Access Compliance Report

Public Rights-of-Way

Intersection ID: 6508	Main Street: MISTY_CREEK_DR	Cross Street: STATESVILLE_RD	Location: SW
ADA ID: 4F84E0AA8D05	Ramp Type: Perp	Initial Pass/Fail: Fail	Overall Compliance: No
			Severity Score: 33.75

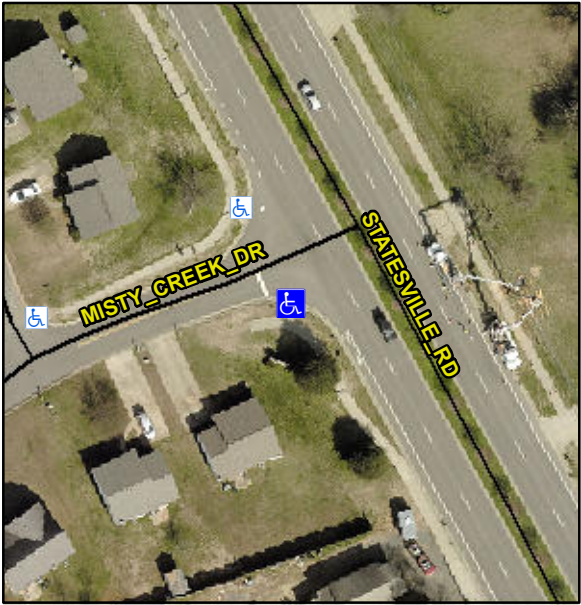
Codes/Mitigation Info/Possible Solution			Field Measurements/Component Compliance		
	Possible Solutions:		Compliance	Description	Data
	Remove & Replace Entire Ramp.		No	Ramp Length (in)	95.0
			No	Ramp Width (in)	46.5
			N/A	Flare Type LT	N/A
			N/A	Flare Slope LT (%)	N/A
			N/A	Flare Traversable LT?	N/A
			N/A	Landing Length (in)	N/A
			N/A	Landing Width (in)	N/A
			N/A	Landing Slope (%)	N/A
			N/A	Landing X Slope (%)	N/A
<p>Surveyor Notes:</p> <p>N/A</p> <p>PROW/ADA:</p> <p>Not Found, R304.5.1, R304.2.2, R304.5.3</p>			N/A	Flare Type RT	N/A
			N/A	Flare Slope RT (%)	N/A
			N/A	Flare Traversable RT?	N/A
			N/A	DWS Provided?	N/A
			N/A	DWS Contrast?	N/A
			N/A	DWS Length (in)	N/A
			N/A	DWS Full Width?	N/A
			N/A	DWS Offset (in)	N/A
			N/A	Gutter Ponding?	N/A
			N/A	Gutter Lip Ht (in)	0.5
<p>Total Cost:</p> <p>\$ 1850.00</p>			No	Painted X Walk1?	N/A
			N/A	X Walk 1 Direction	To N
			N/A	X Walk 1 Width (in)	N/A

N/A	X Walk 1 Slope (%)	0.1
			N/A	X Walk 1 X Slope (%)	4.1
			N/A	Ramp inside XWalk1?	N/A
			N/A	Road Slope (%)	N/A
			N/A	Road X Slope (%)	N/A
			N/A	Any Obstructions?	N/A
			N/A	Obstruction Type	N/A
			N/A	Clear Space?	N/A
			N/A	Clear Space to XWalk (in)	N/A
			N/A	Storm Grate/Utility Hazard?	N/A
			N/A	Storm Grate/Utility Type	N/A
			Yes	Surface Condition? (G/P)	Good
